RE: Central Florida Power Limited Partnership,  
Tiger Bay Cogeneration Plant (PSD-FL-190)

RE: Central Florida Power Limited Partnership (CFPLP)  
Tiger Bay Cogeneration Plant  
AC 53-214903; PSD-FL-190

Re: Central Florida Power Limited Partnership  
Tiger Bay Cogeneration Plant  
PSD-FL-190  
AC 53-214903

Re: Central Florida Power Limited Partnership  
Tiger Bay (formerly Central Florida) cogeneration plant  
PSD-FL-190  
AC 53-214903

Figure 1 TIGER BAY CONCEPTUAL DRAWING OF STACK AND ADJOINING STRUCTURE

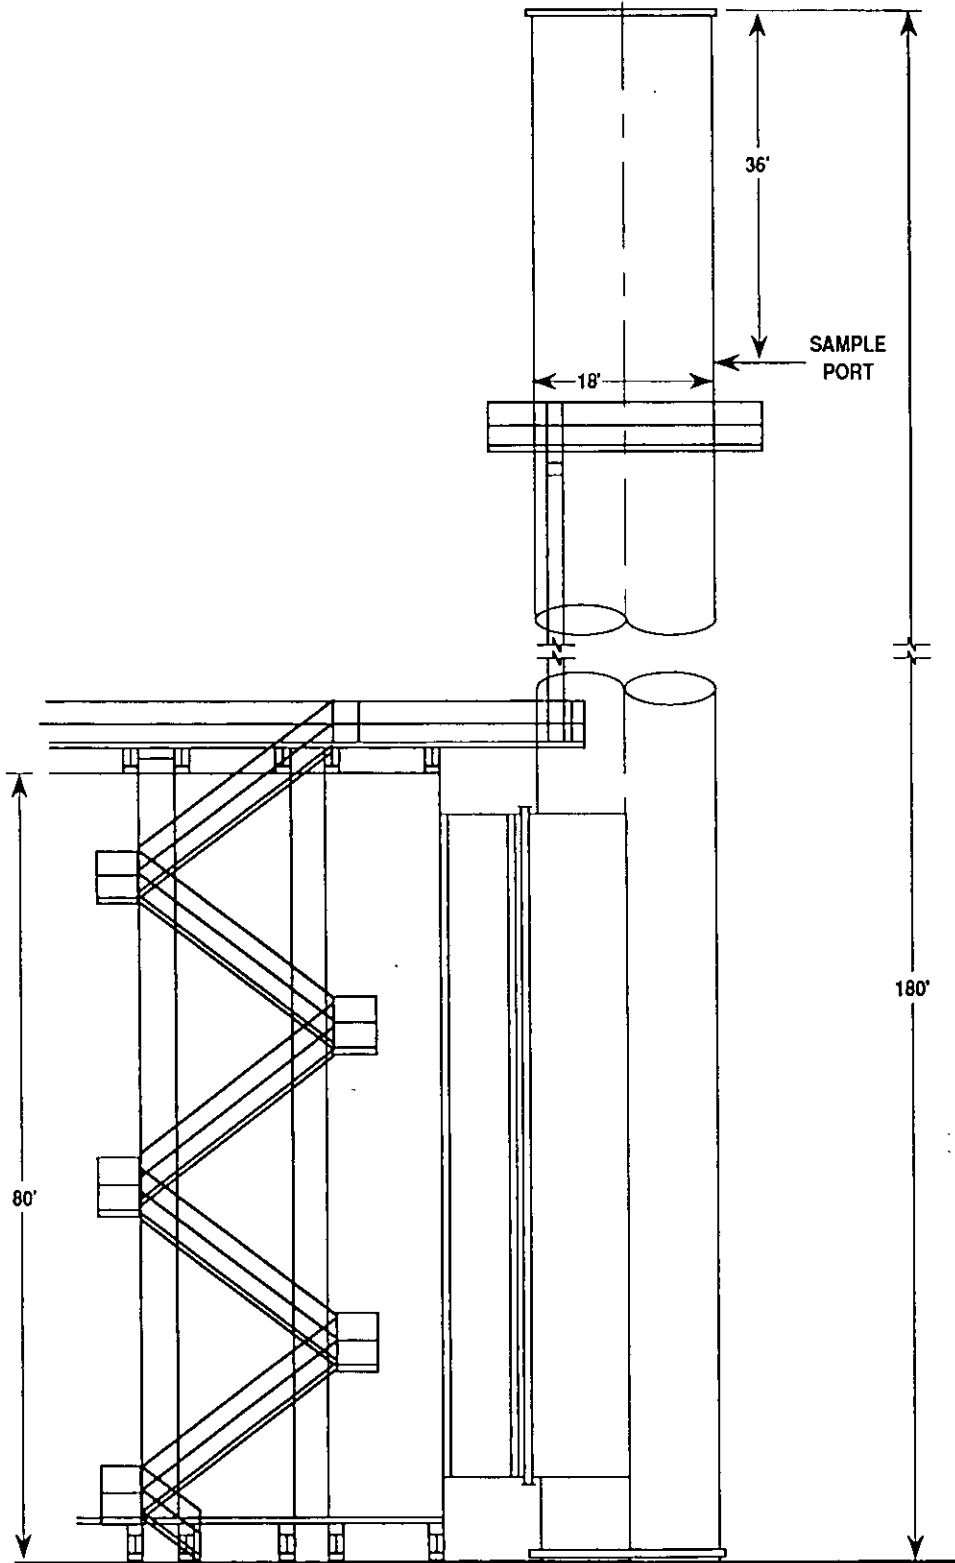
12. COMMENT (via July 15, 1992, telephone conversation): Please provide a diagram indicating the proposed location of the sample ports for source sampling purposes. Show these locations with respect to the proposed stack and HRSG unit.

RESPONSE: The stack sample port location is depicted in Figure 1. The sample port will be accessible by ladder from the top of the HRSG to a platform assembly near the port location.

**PROCESS FLOW DIAGRAMS  
FOR THE COMBUSTION TURBINE  
FIRING NATURAL GAS AND OIL**

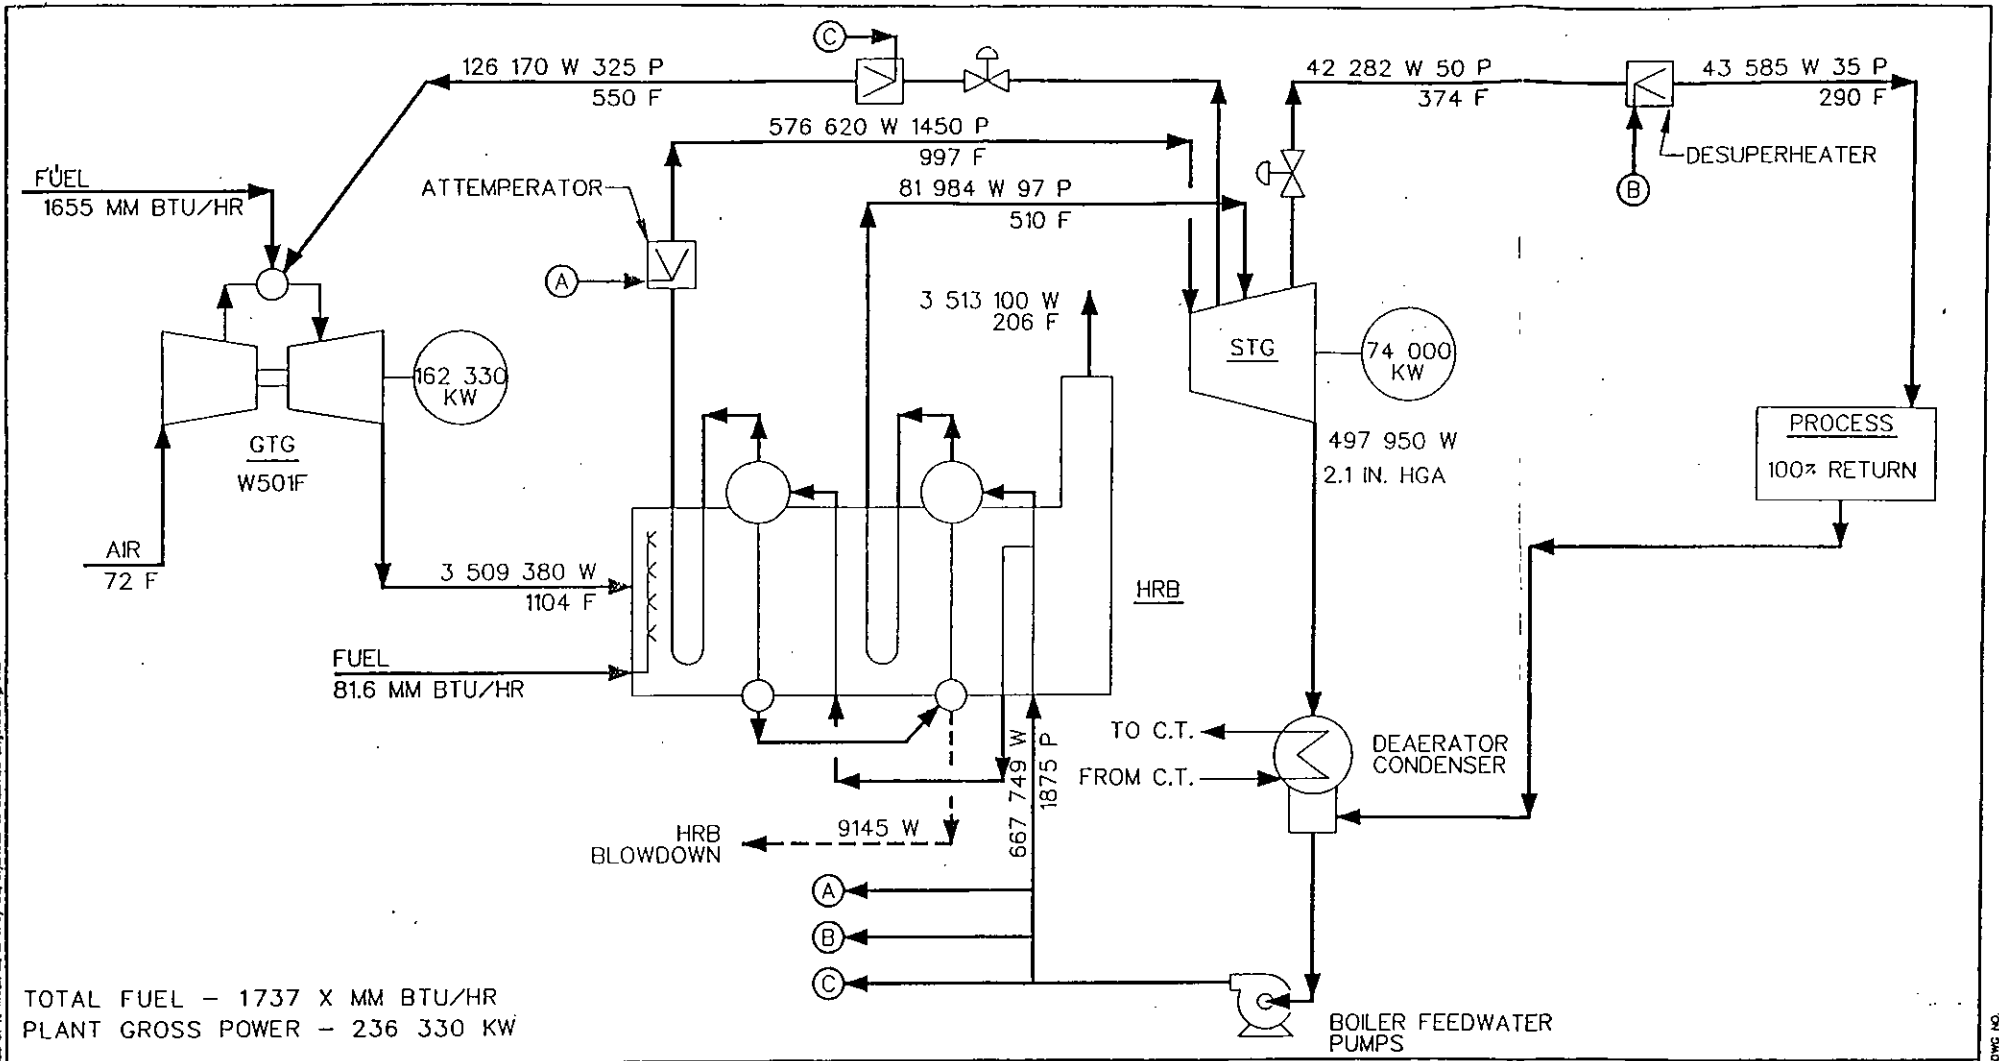
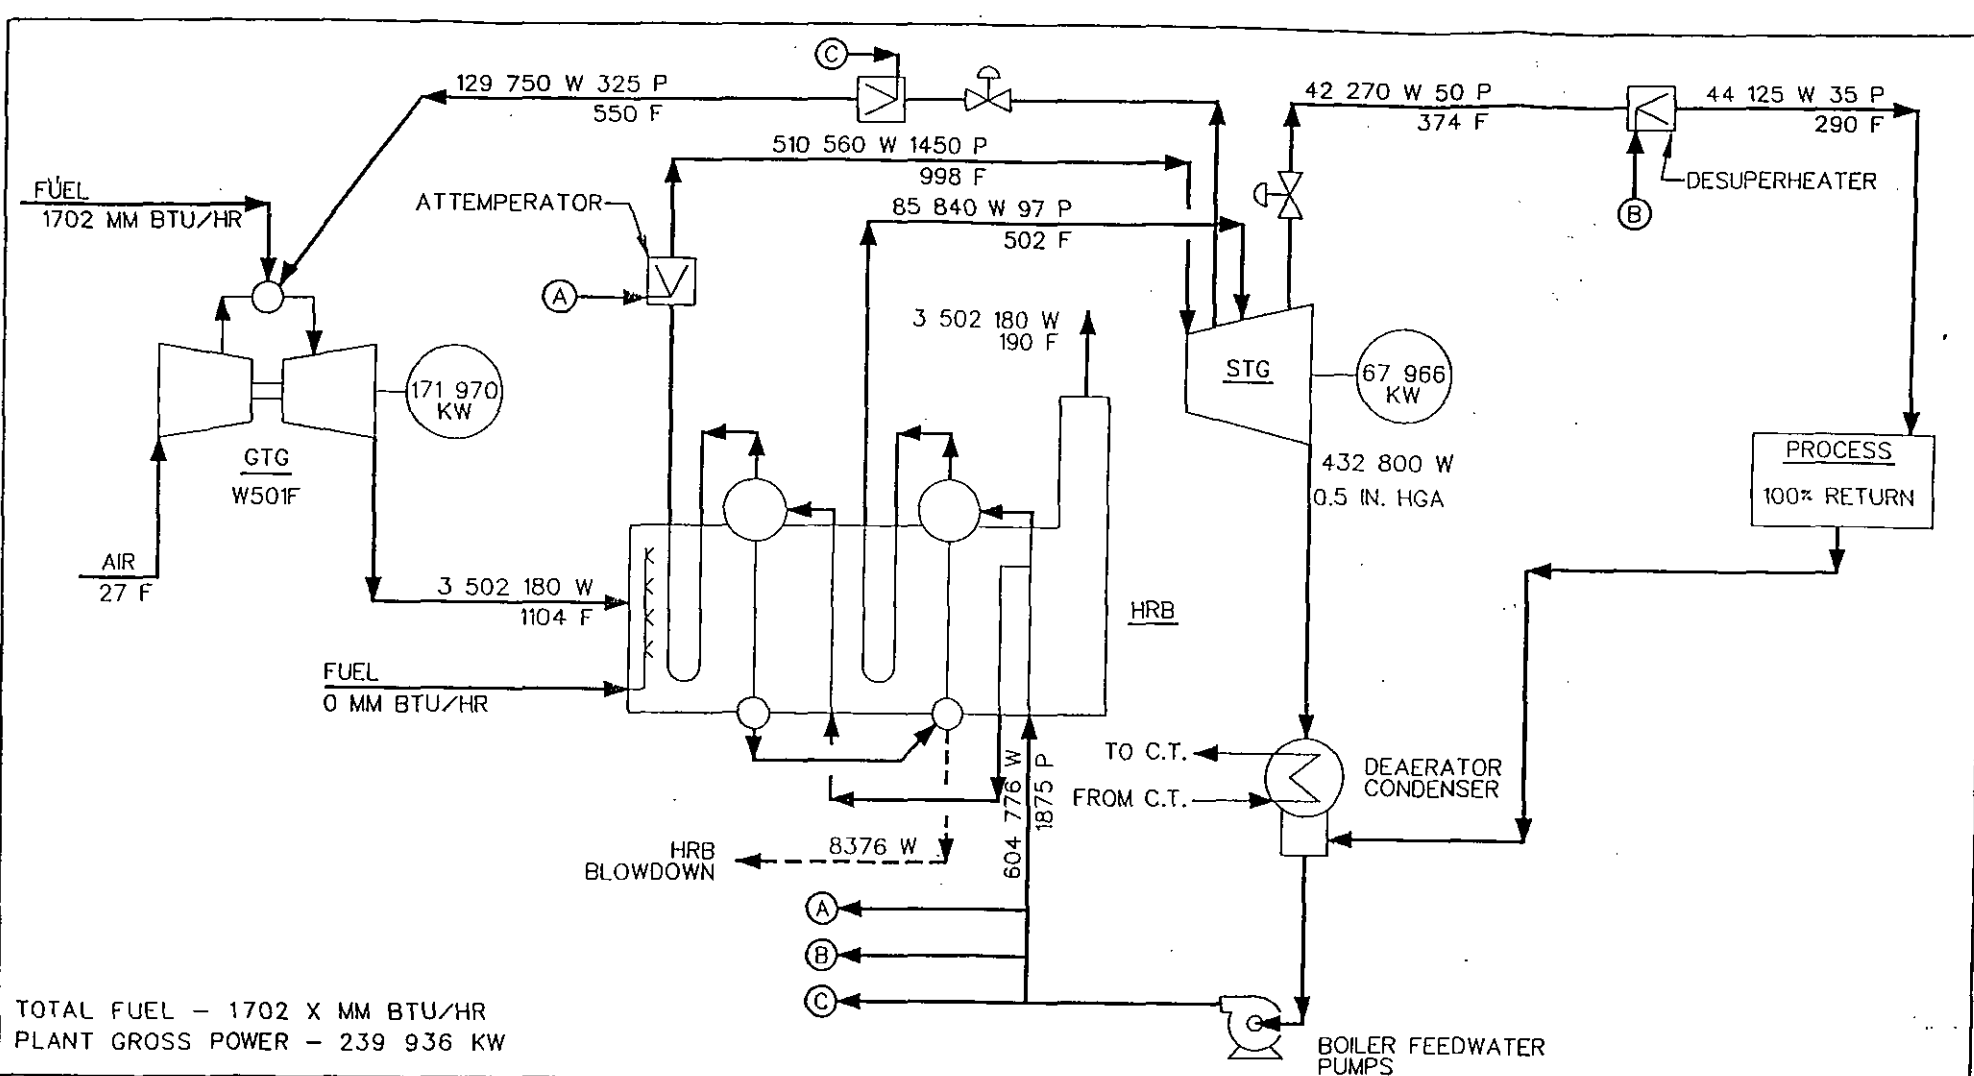
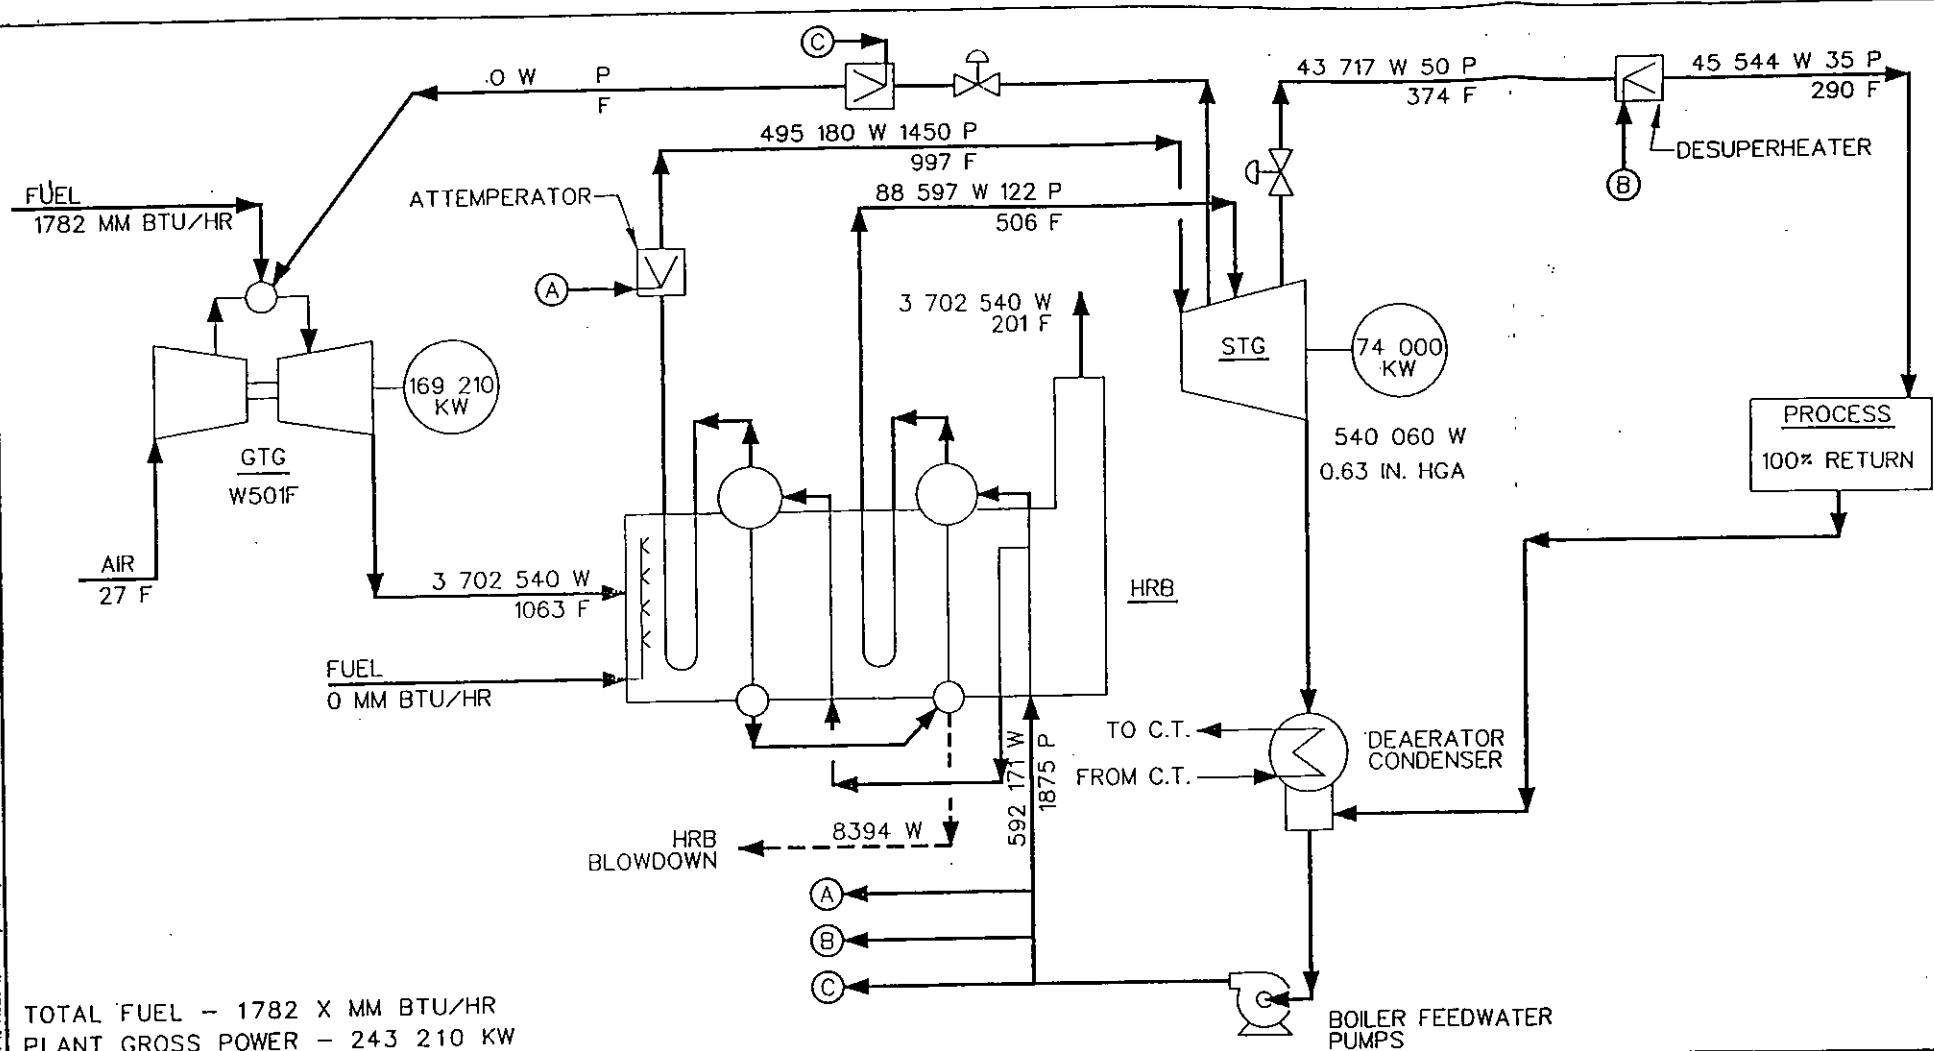
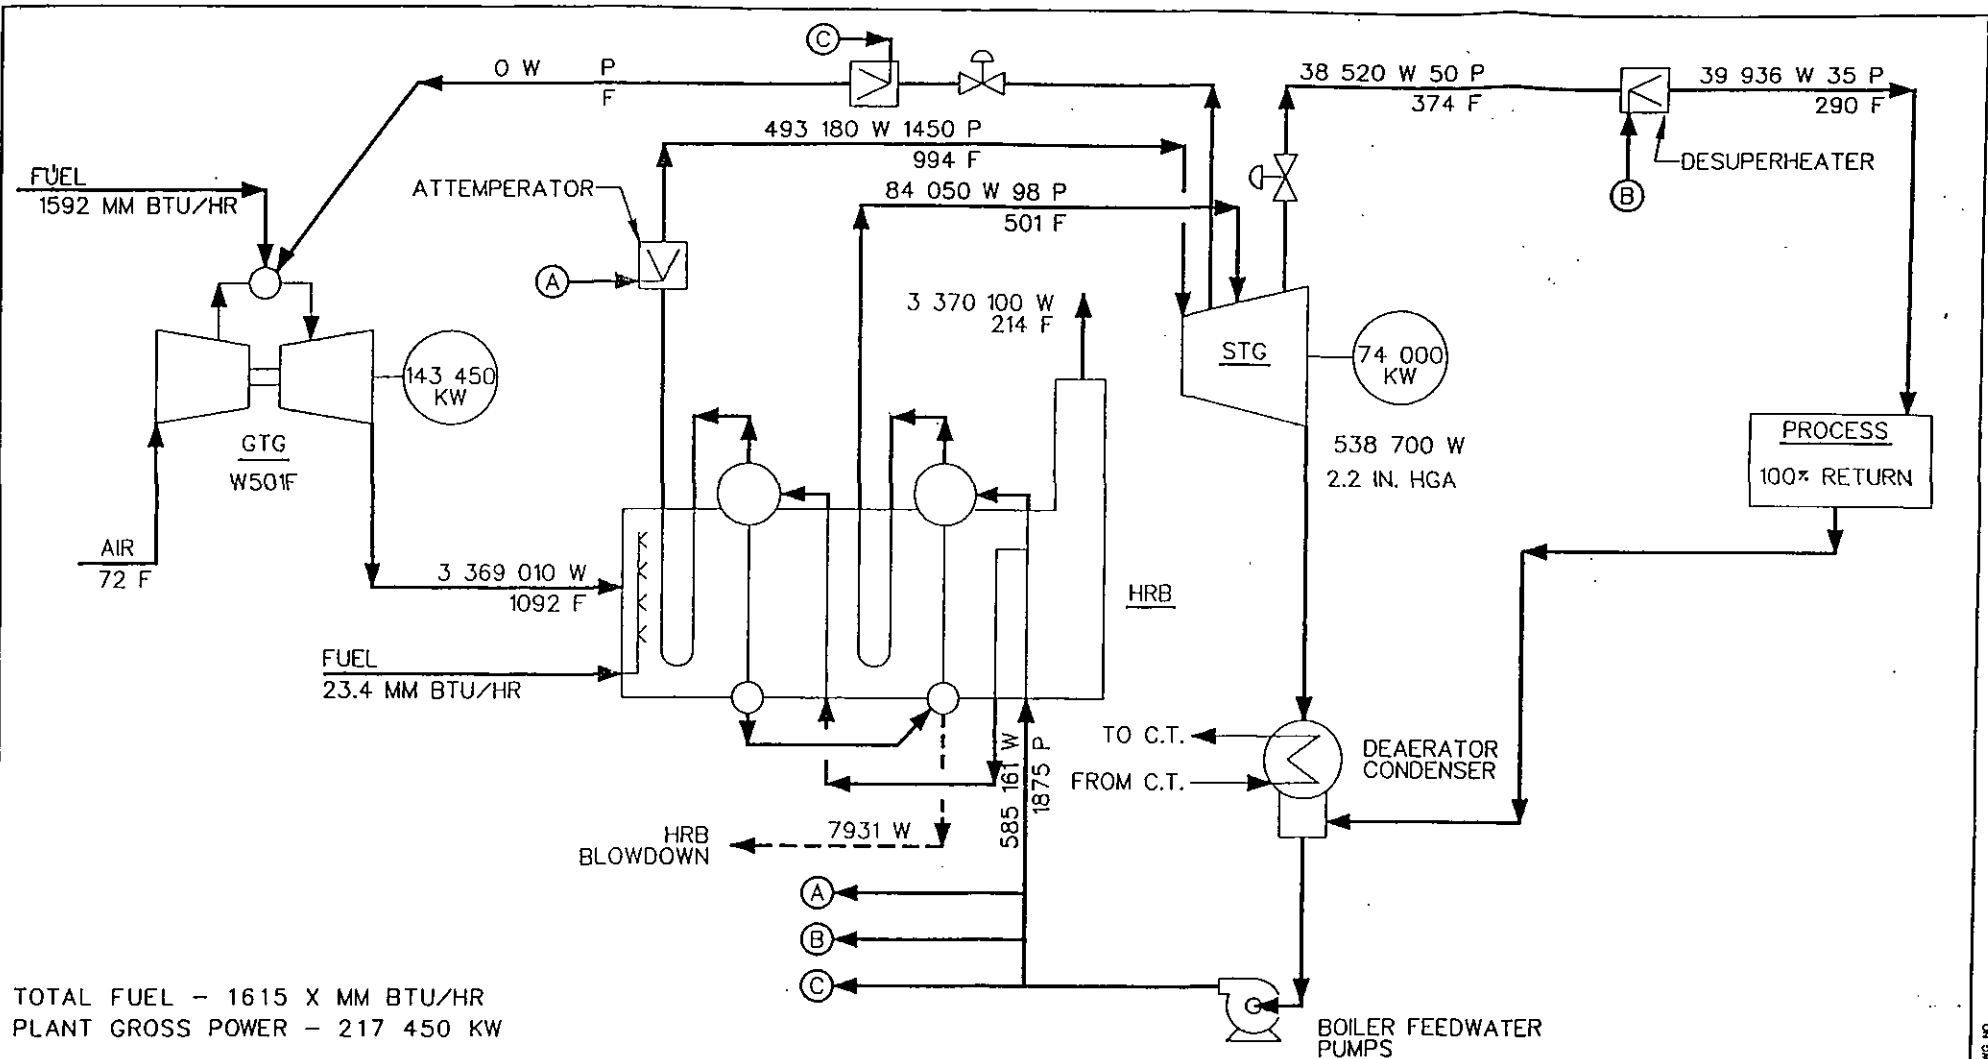
4. **COMMENT:** Submit an updated process flow diagram showing steam turbine and volumetric air flow rates.

**RESPONSE:** Updated process flow diagrams showing the steam turbine and the mass energy balance around the steam turbine and gas turbine are presented in Attachment 3 for natural gas and fuel oil firing.
